Product Change Notification

Senseair Sunrise, Article Number: 006-0-0002

Senseair Sunrise, Article Number: 006-0-0007

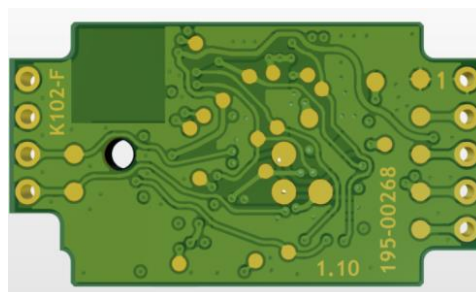
- Default power consumption increased to 45µA instead of 38µA at 8 samples and 16sec measurement period in continuous mode.
- Steady state current during sampling increased to 99mA instead of 85mA.
